**Town of Kittery  
Planning Board Meeting  
October 26, 2023**

**ITEM 4 – 77 Bartlett Road – Conservation Subdivision Plan – Preliminary Review**

**SUBJECT: BARTLETT ROAD SUBDIVISION  
RESPONSE TO PEER REVIEW COMMENTS**

PROJECT: BARTLETT ROAD SUBDIVISION  
 KITTERY, MAINE  
 SHEET TITLE: SUBDIVISION PLAN  
 CLIENT: BEACHWOOD DEVELOPMENT FUND  
 KENNEBUNK, MAINE 04043

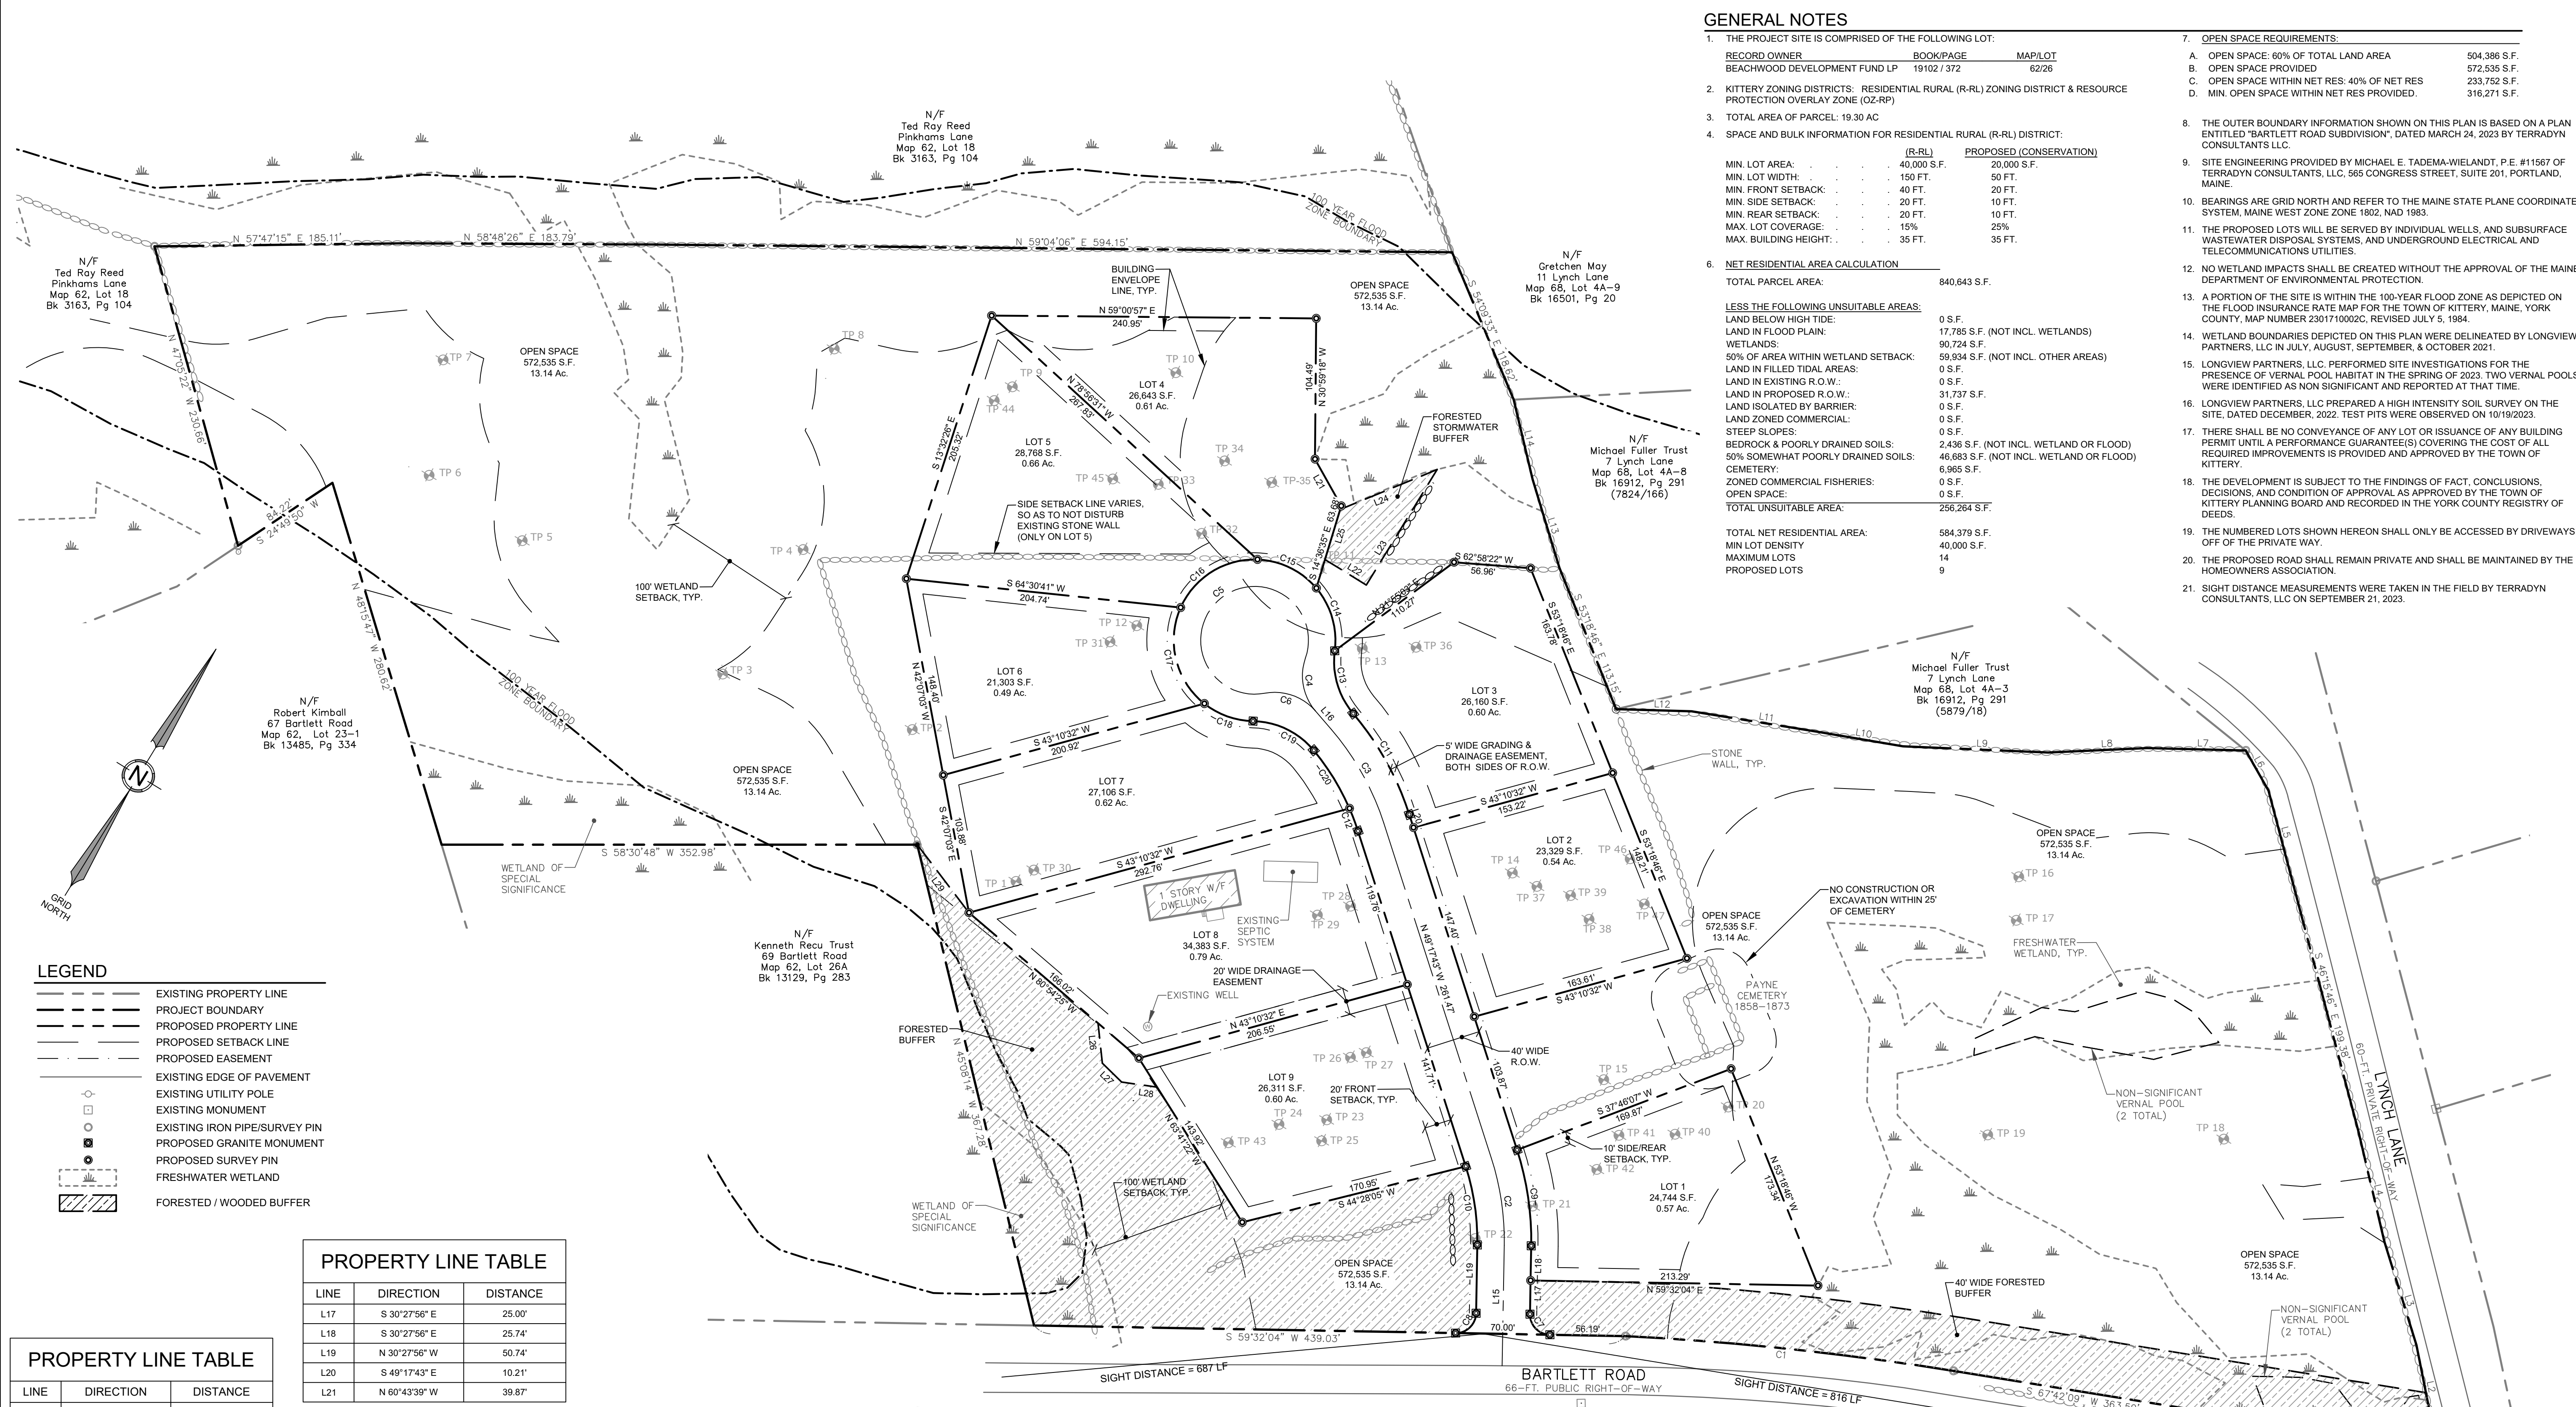
- 56  
57  
58 1. Following feedback from the public hearing, the applicant has extended the vegetated buffer  
59 between Lot 9 and Bartlett Road. The setback area between Lot 5, Lot 8, and the abutting wetland  
60 is now designated a forested stormwater buffer area.  
61 2. At the public hearing, a resident expressed concerns that the disturbed soil calculations appeared  
62 inaccurate. The planning board requested revised calculations to determine whether the proposal  
63 meets the 1-acre threshold of disturbed soil to require a permit from Maine DEP.  
64 3. At the first preliminary review, the planning board requested the applicant show proof that a  
65 community water system was too costly to provide instead of private wells for each individual lot.  
66 4. A 40-foot right-of-way is proposed, with a 5-foot grading and drainage easement along both sides  
67 of the ROW. The proposed road shall be private and maintained by a homeowner's association.

68 5. Part of the cul-de-sac is within 100 feet of the wetland. §16.5.30 requires traveled ways greater than  
69 18 feet in width only maintain a 30-foot setback, or 10 feet from the toe of the slope, whichever is  
70 greater.  
71 6. The water report confirms the recharge capacity of the aquifer is greater than the anticipated water  
72 usage of the proposed wells, and the bedrock is a good site for wells to be dug.  
73 7. The Maine Department of Inland Fisheries and Wildlife does not anticipate essential habitats to be  
74 directly affected by the project. Endangered, threatened, and significant wildlife have not been  
75 identified in the parcel area, and impact to nearby identified habitats is not anticipated.  
76 8. Because the conservation subdivision ordinance strongly recommends all buildings within the  
77 subdivision be designed for maximum energy efficiency per §16.10.6.A.(4), it is suggested that

**Response:** Site distance information for the proposed road has been added to the Subdivision Plan (Sheet C-3.0) and the Plan & Profile (Sheet C-3.1).

Response: The right-of-way width is noted on sheet C-3.0

SHEET TITLE: PLAN & PROFILE, UTILITY, & EROSION CONTROL PLAN

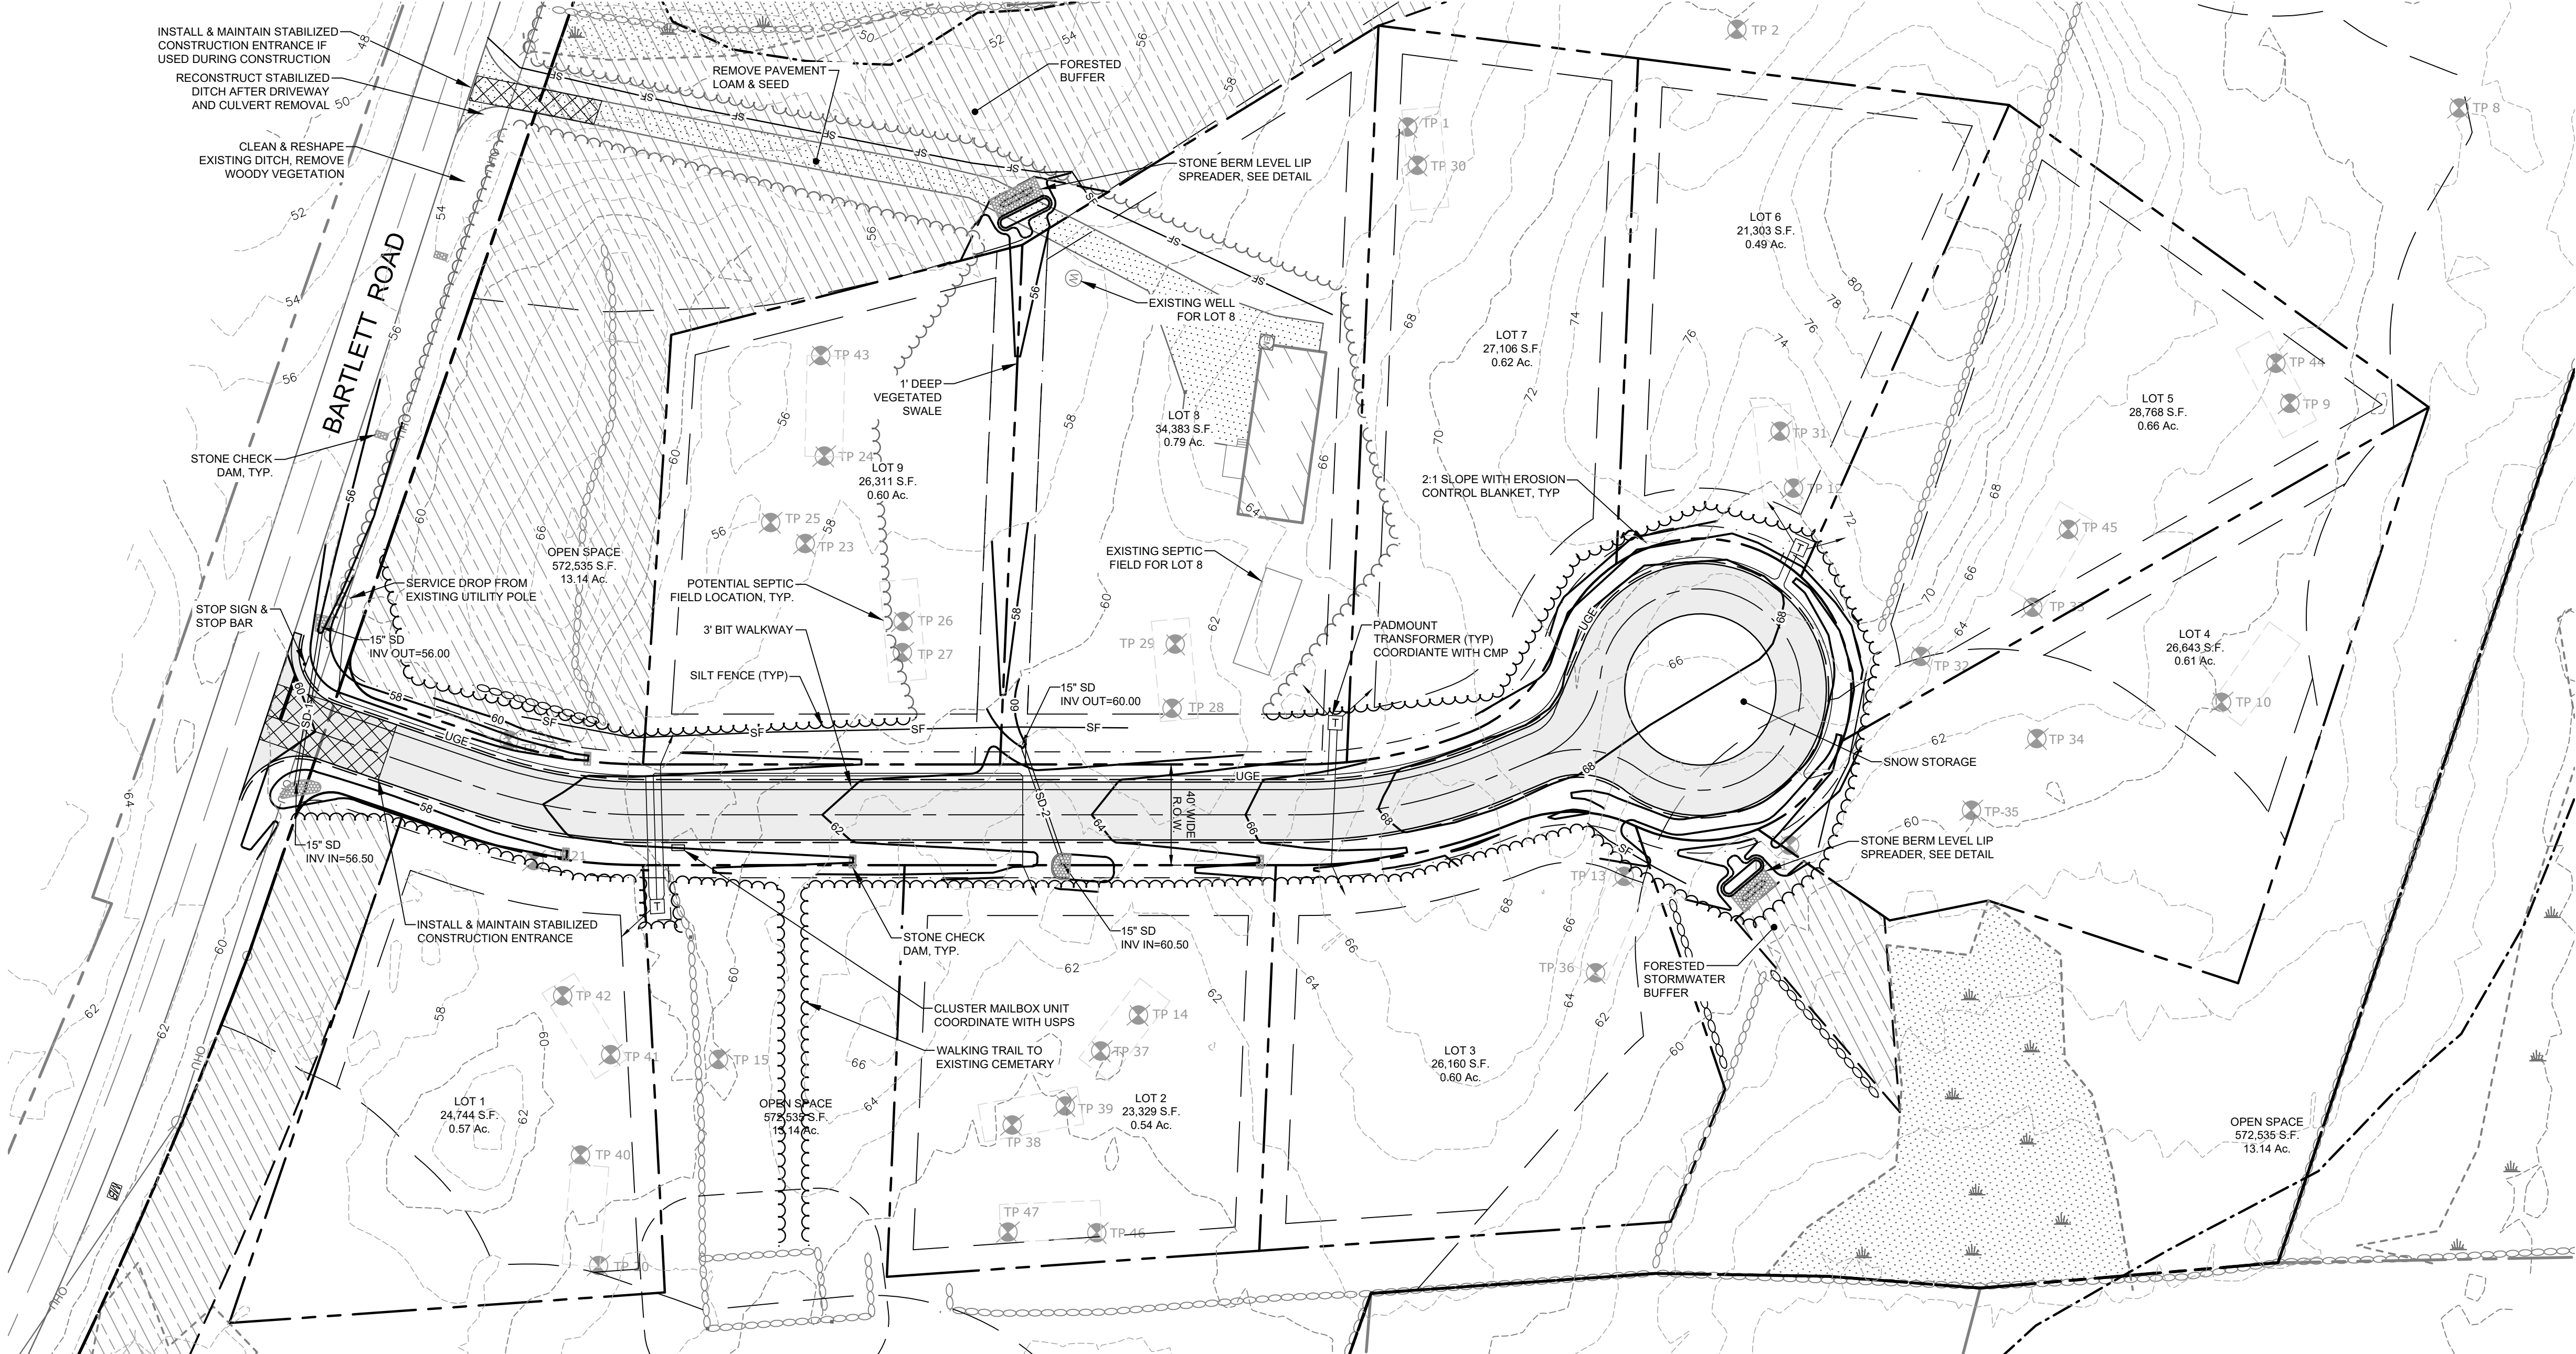
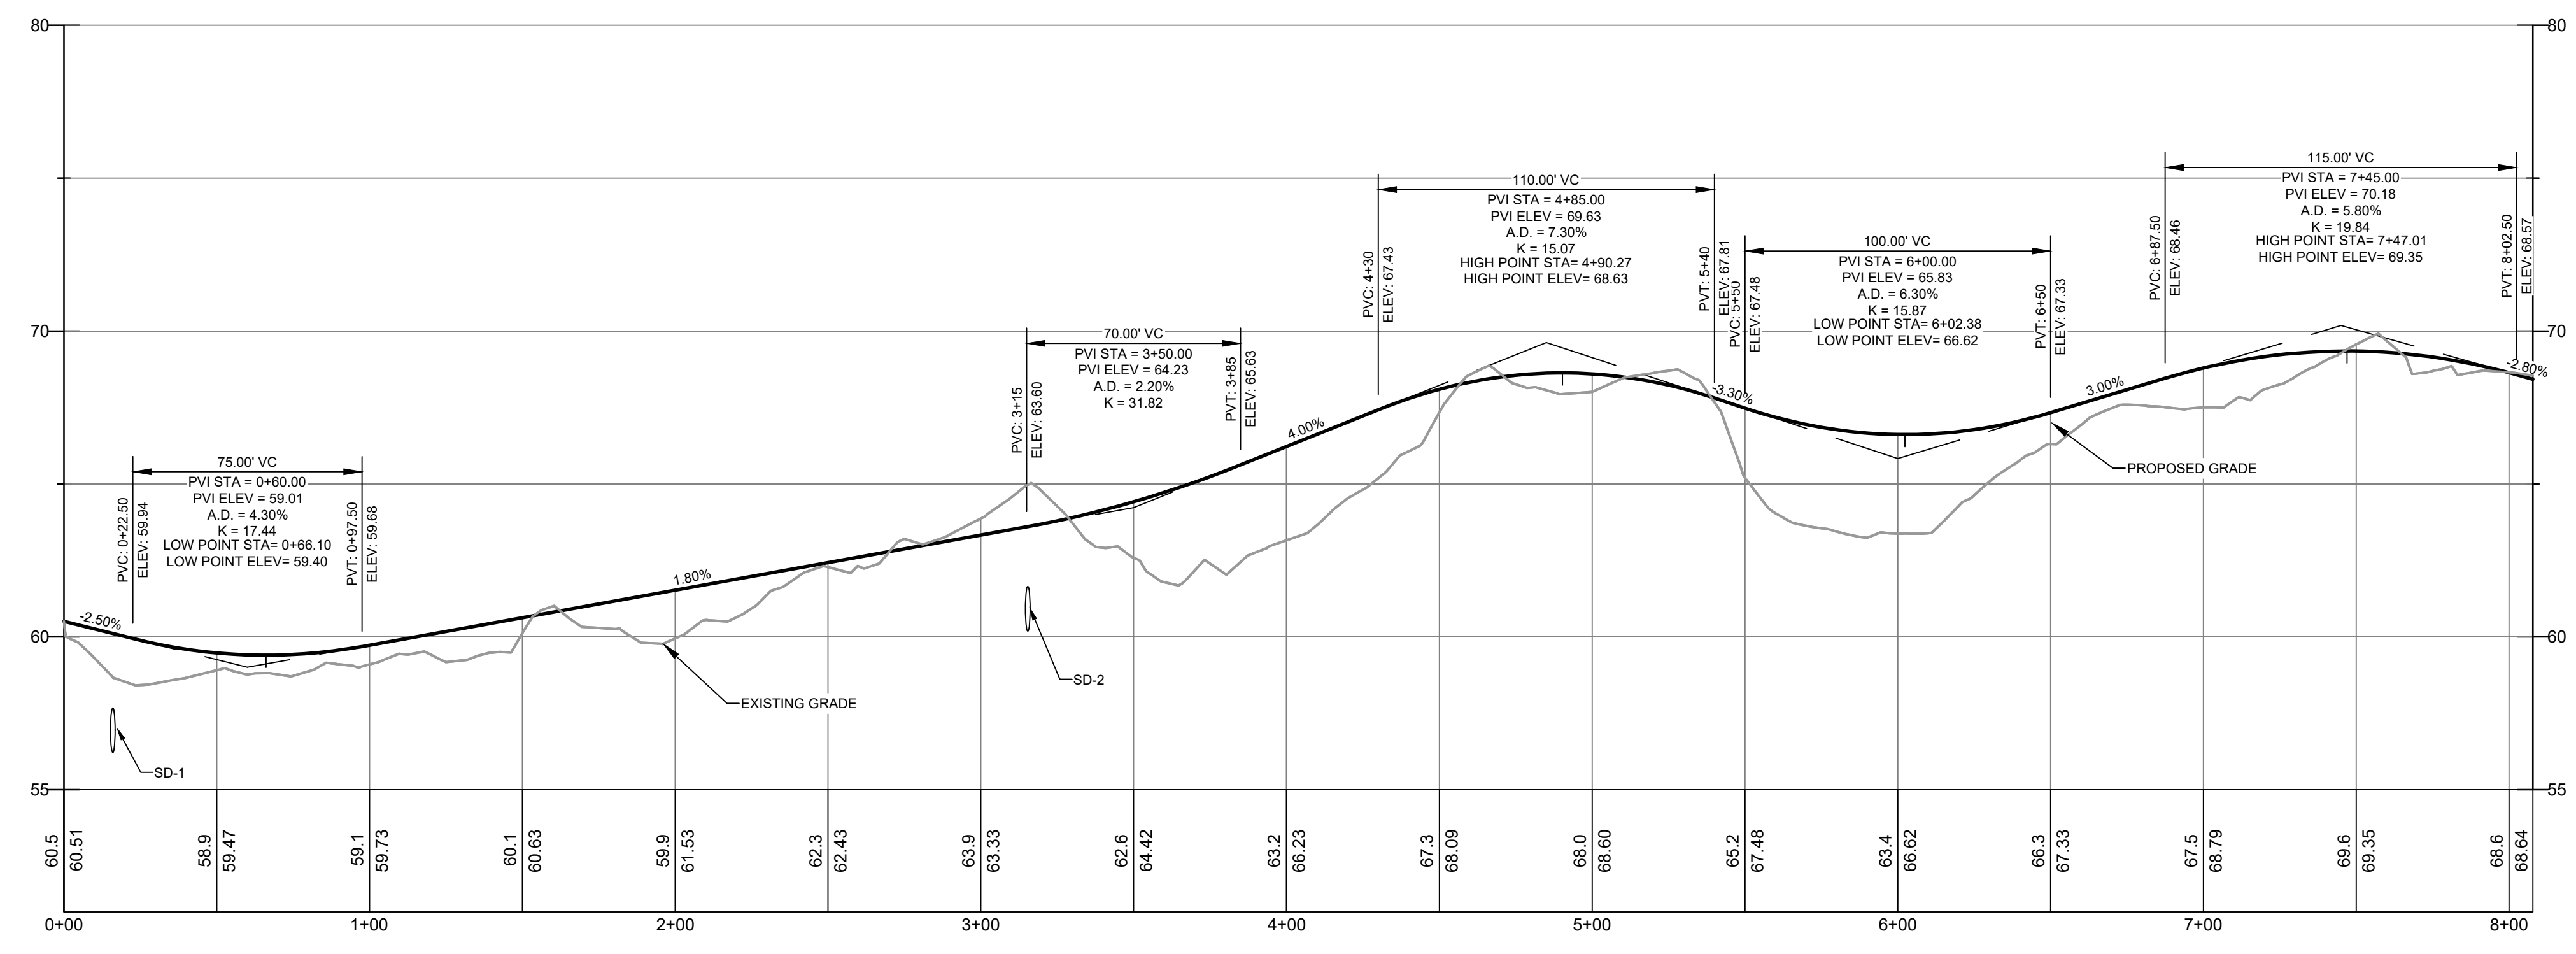
**Comment 4:** 16.5.27.H.(4) *The site distance in both directions on Bartlett Road should be indicated on the plans.*
